Bid Bulletin #03

PROJECT: Educare of Winnebago
Bid Package #04
Winnebago, NE

ADDENDUM H

Educare Winnebago
Winnebago, Nebraska
RDG Project No. 2010.175.00, File 35.1

2010.175.01
 45.2
SDA-014

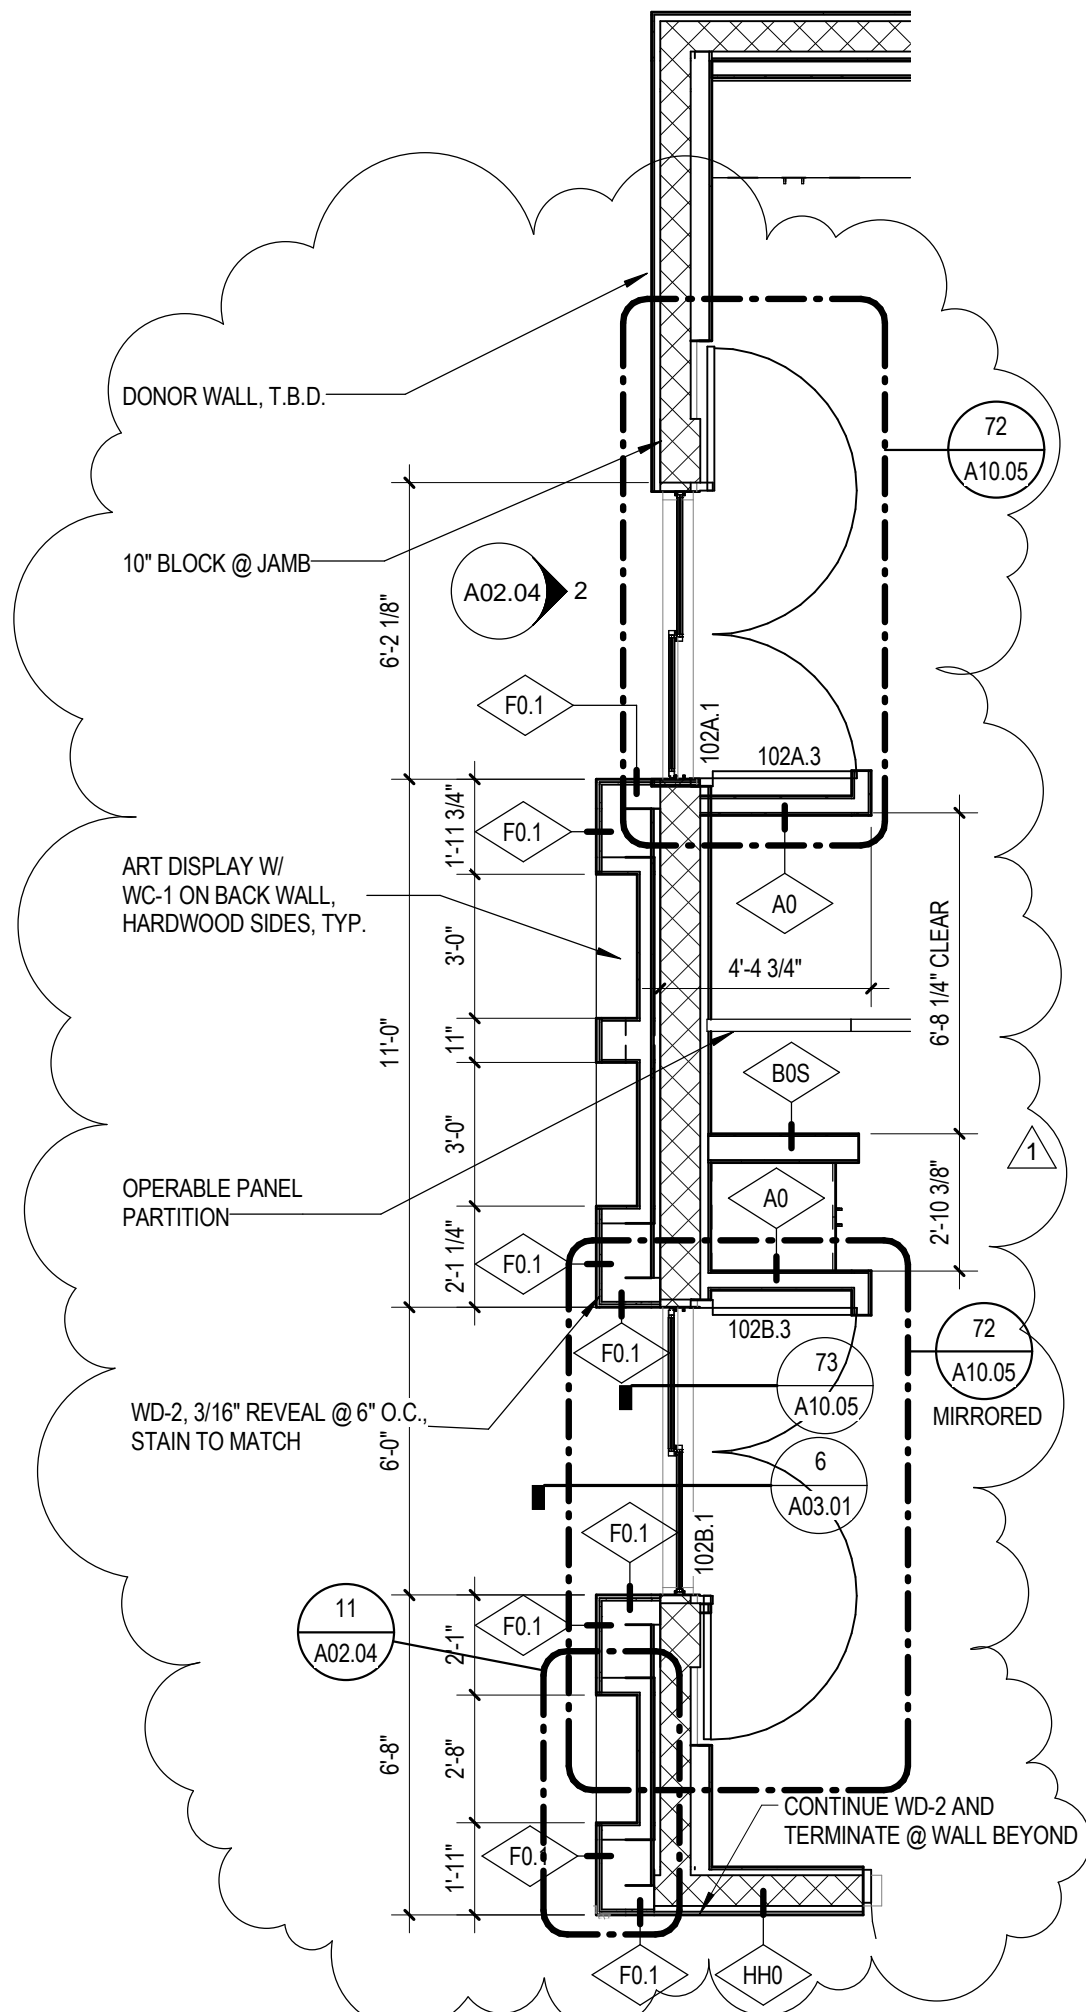
HGD-1 Sheet A01.01, Slab Plan North: Revise structural stoop layout dimensions at Door 101E per attached Supplemental Drawing SDA-014.

2010.175.01
 45.2
 SDA-016

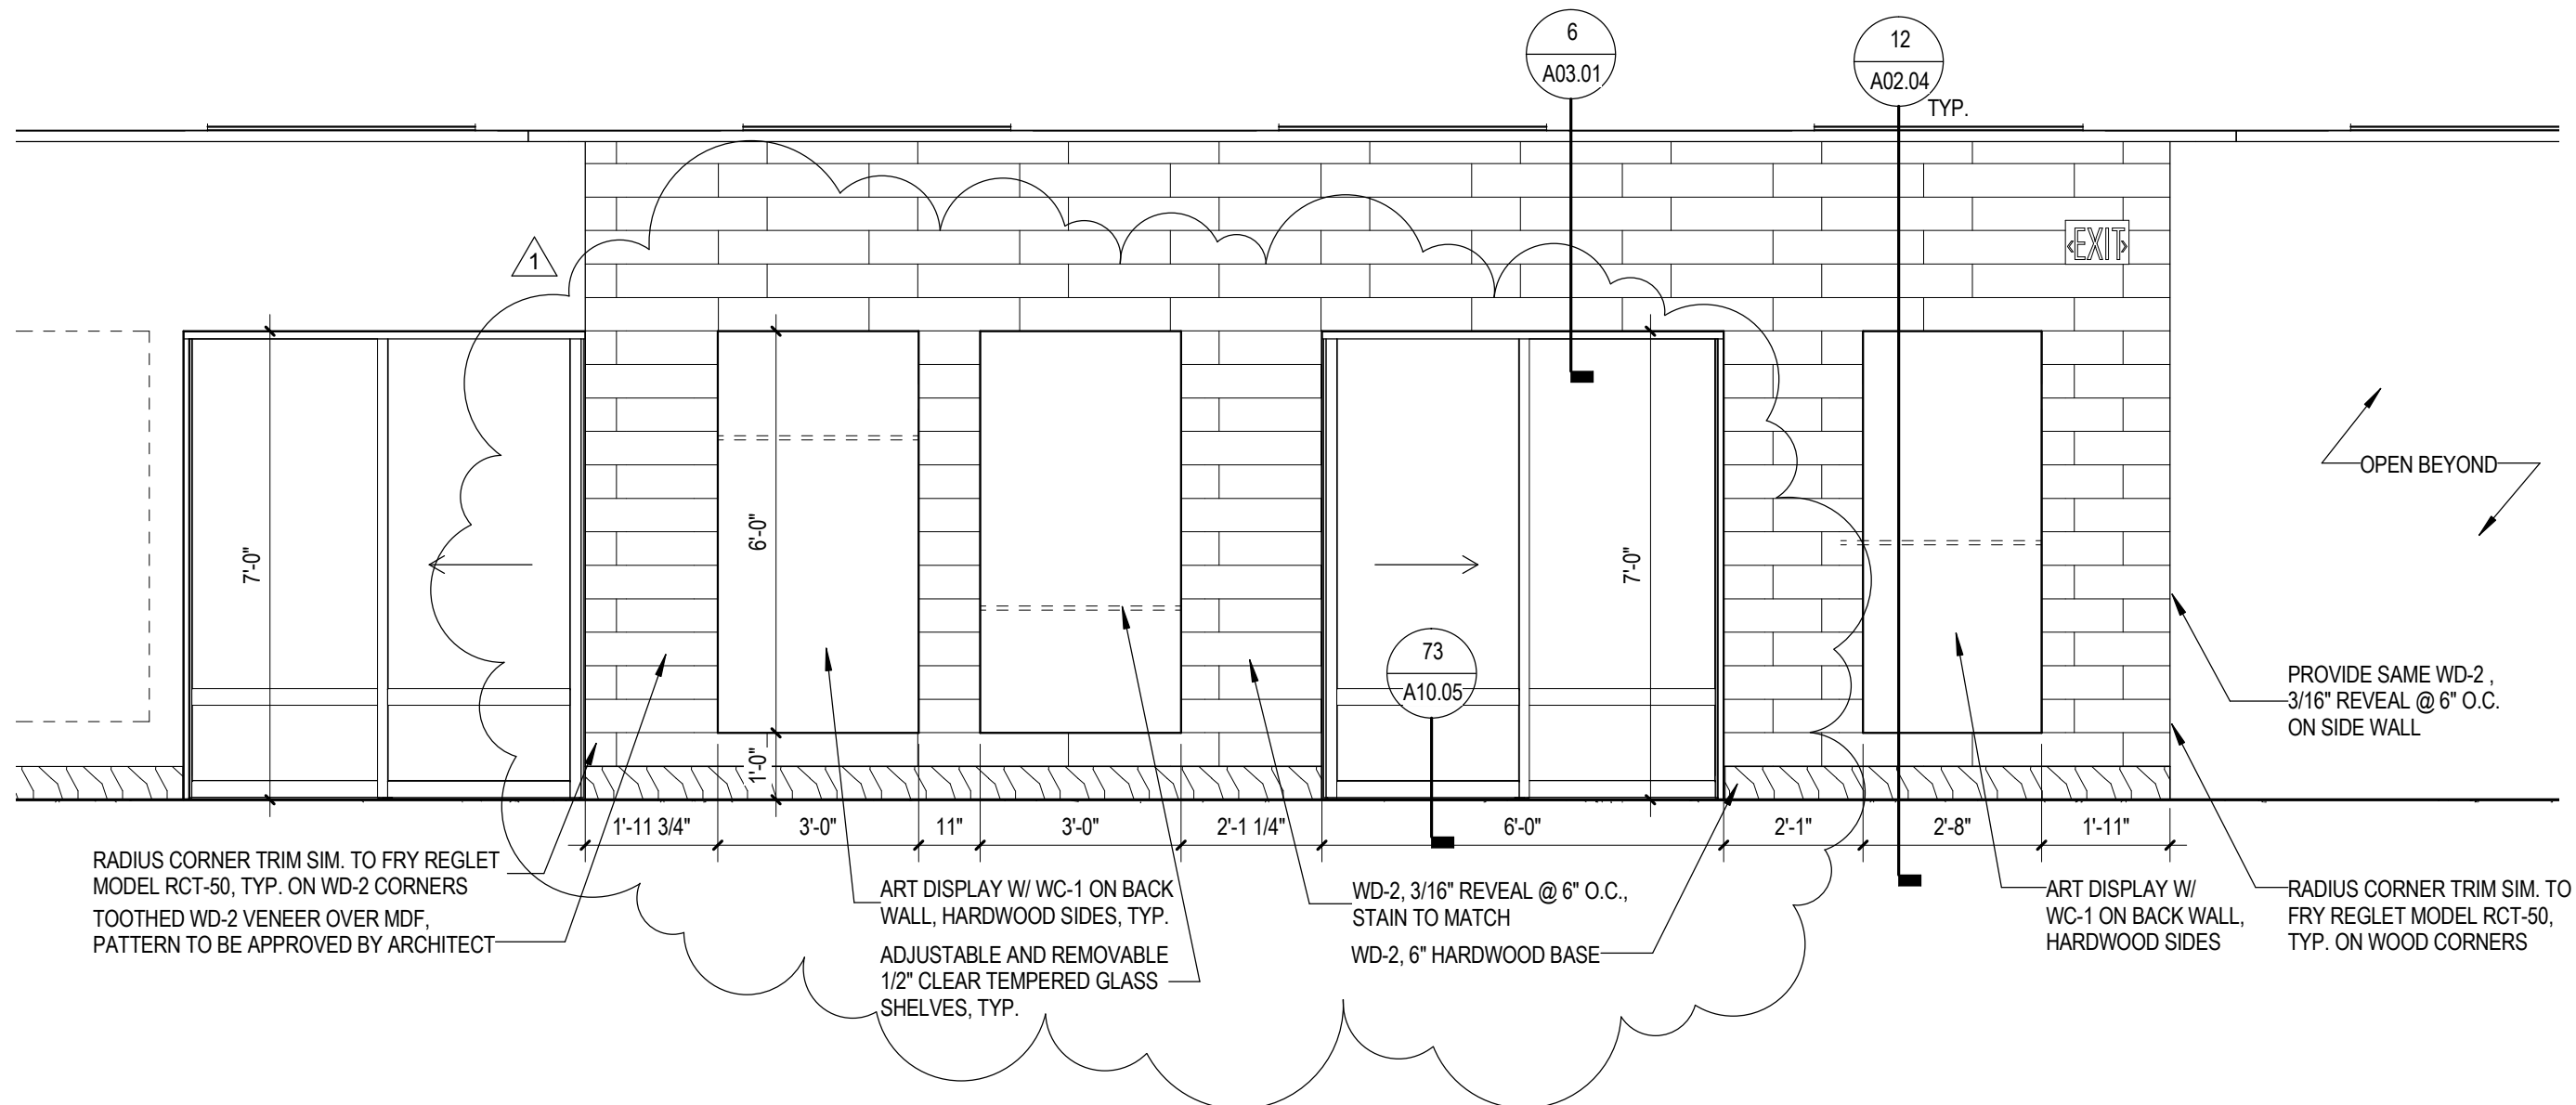
- A. Detail 1, Hearth – Art Display: Revise layout at door openings to show the modification of the overhead doors to a pair of doors. See attached Supplemental Drawing SDA-015 for clarity of revision.
- B. Detail 2, Art Display Wall in Hearth: Revise dimensional layout to show the modification of the overhead doors to a pair of doors. See attached Supplemental Drawings SDA-016.

2010.175.01
 45.2
SDA-017

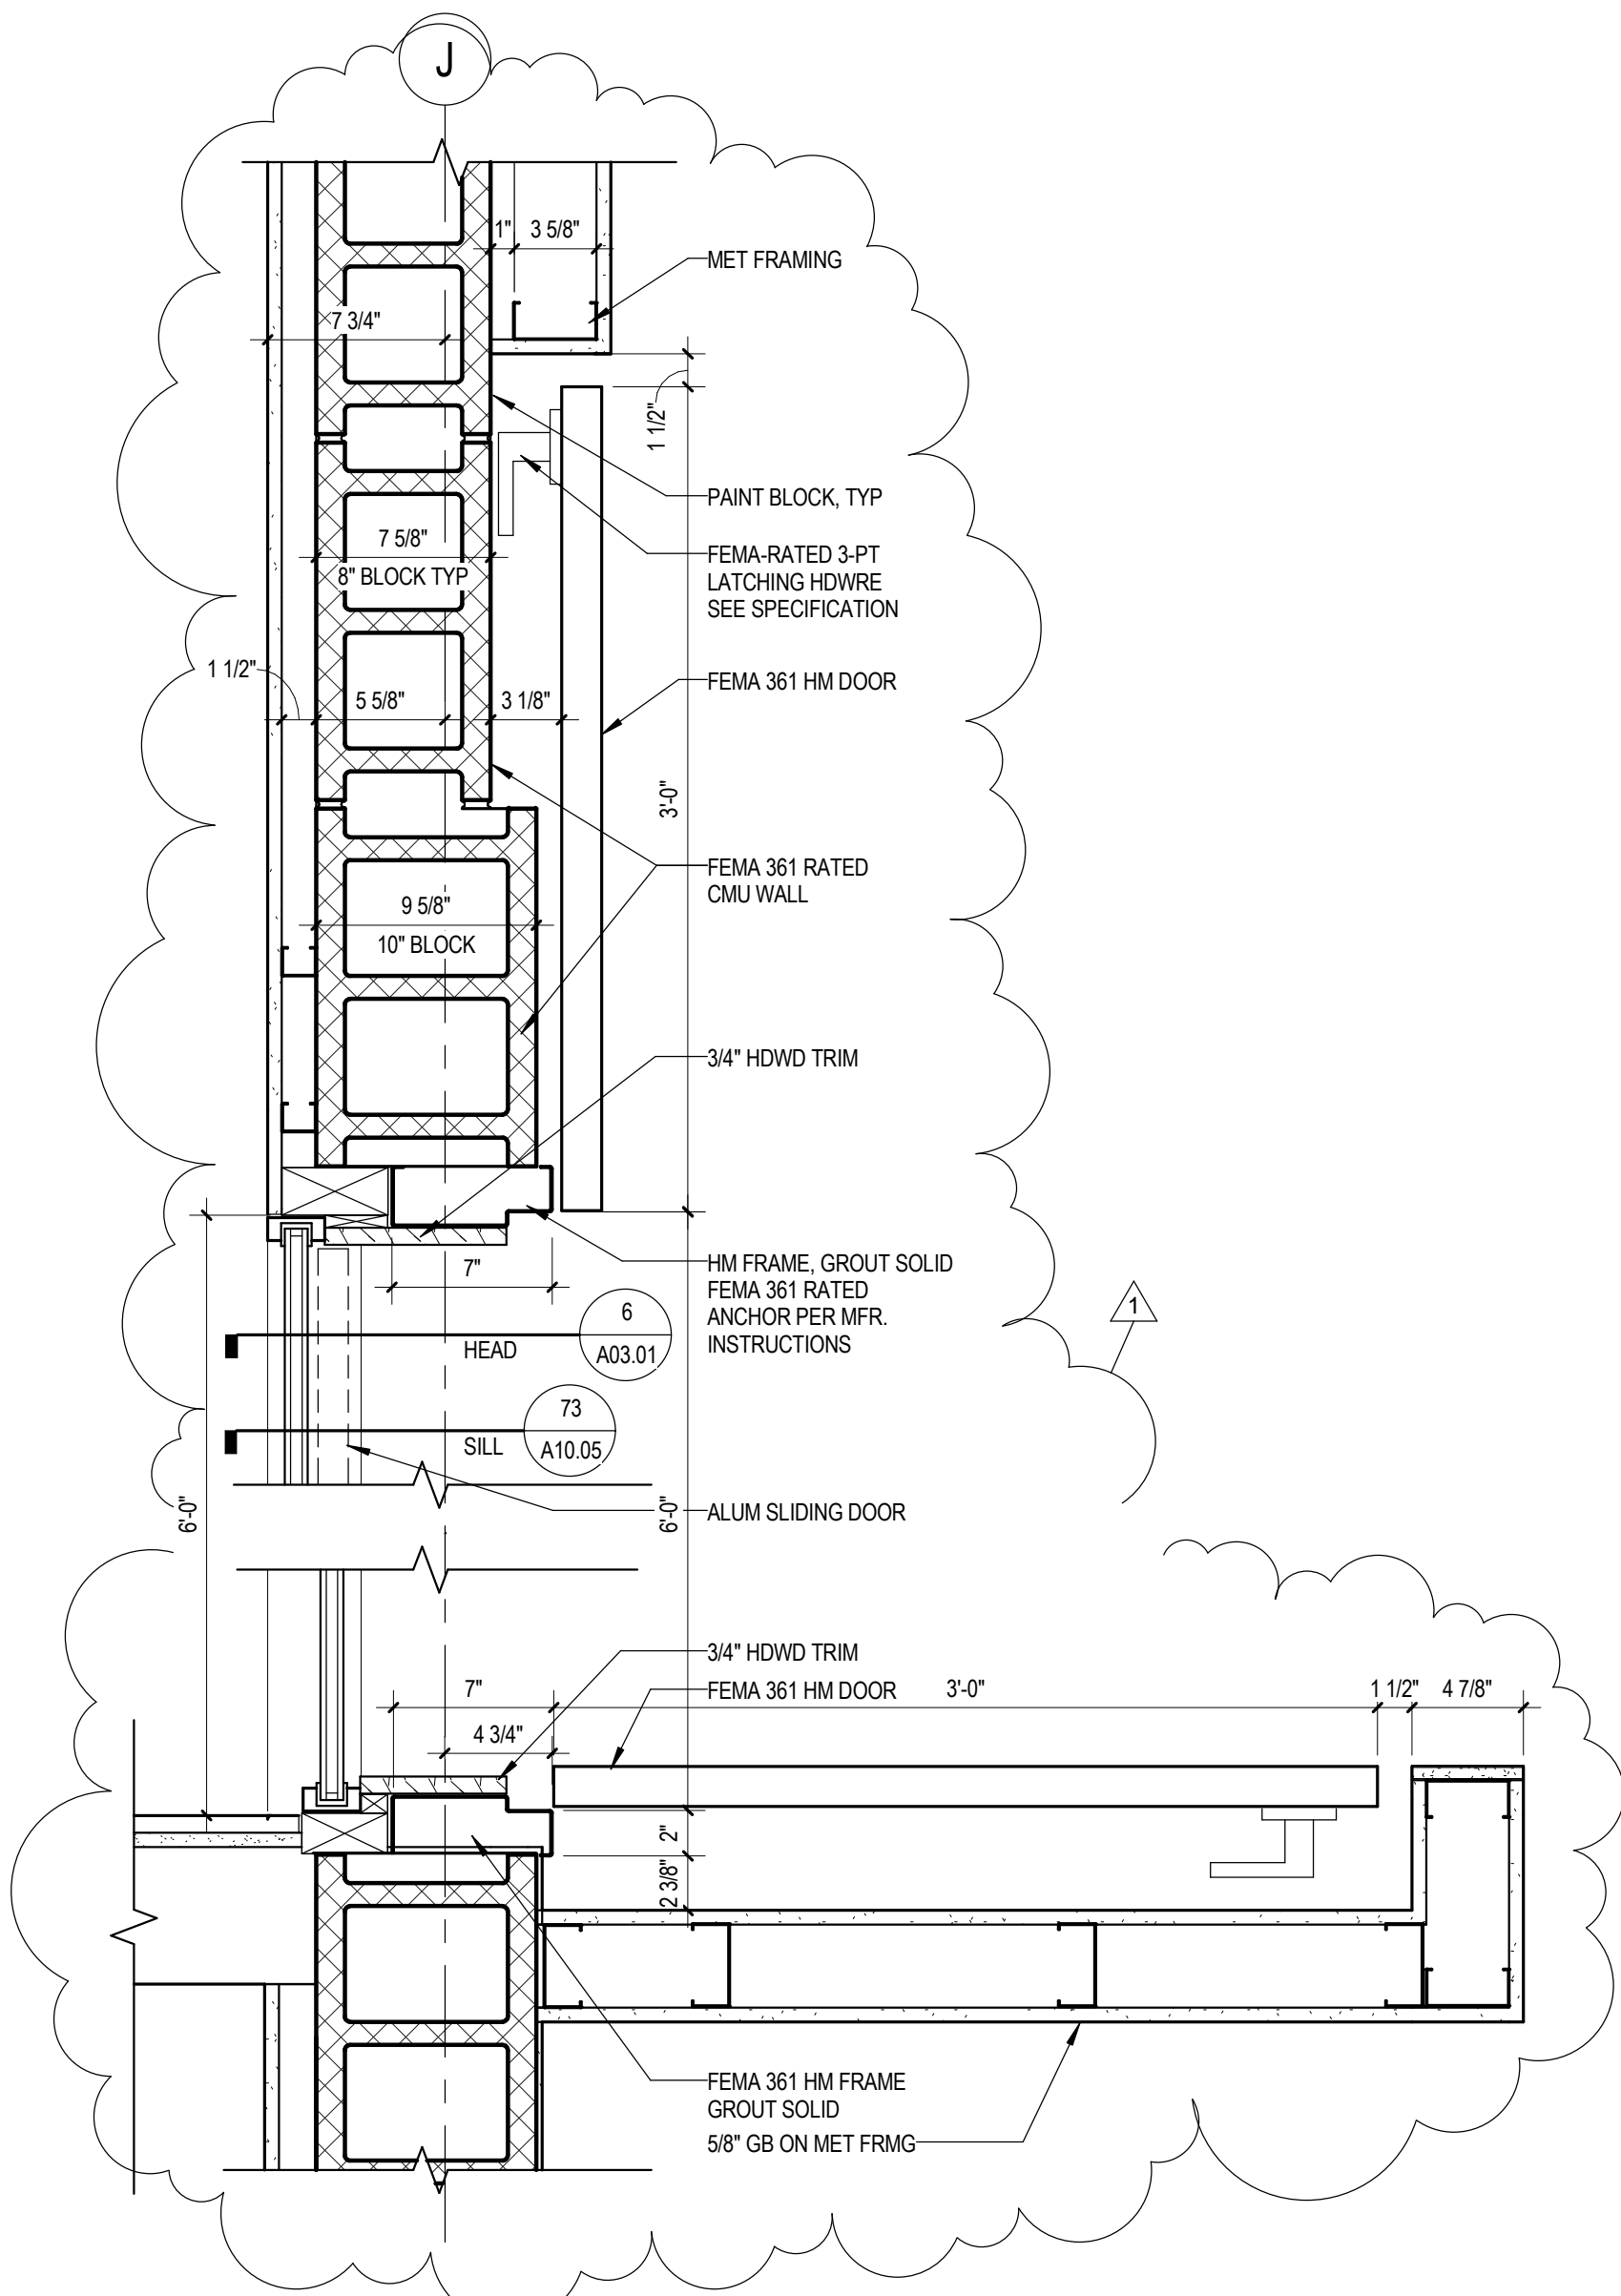
HGD-3 Sheet A03.01, Reflected Ceiling Plan North, Detail 6, Training Room Door to Hearth: Revise detail to show the modification of the overhead doors to a pair of doors. See attached Supplemental Drawing SDA-017.

2010.175.01
 45.2
 SDA-018

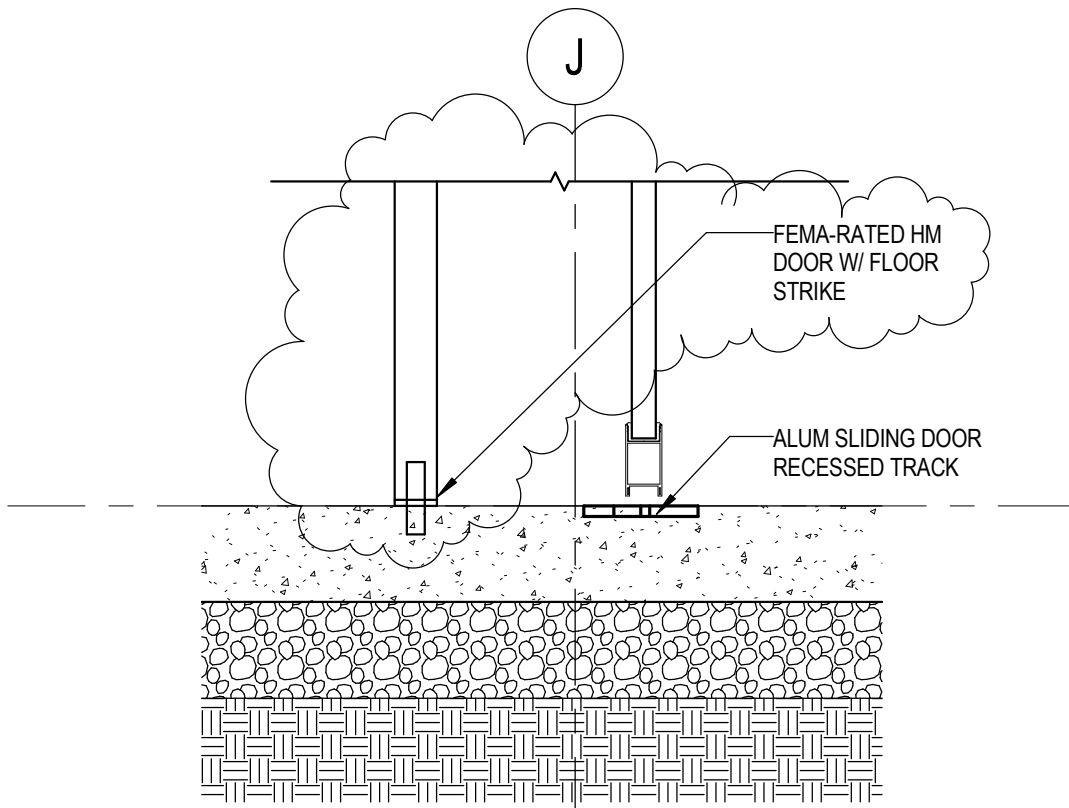
- A. Detail 72, 102B Jamb: Revise per attached Supplemental Drawing SDA-018.
- B. Detail 73, 102B Sill: Revise per attached Supplemental Drawing SDA-019.
- C. Detail 79, 102B Jamb: Delete detail.
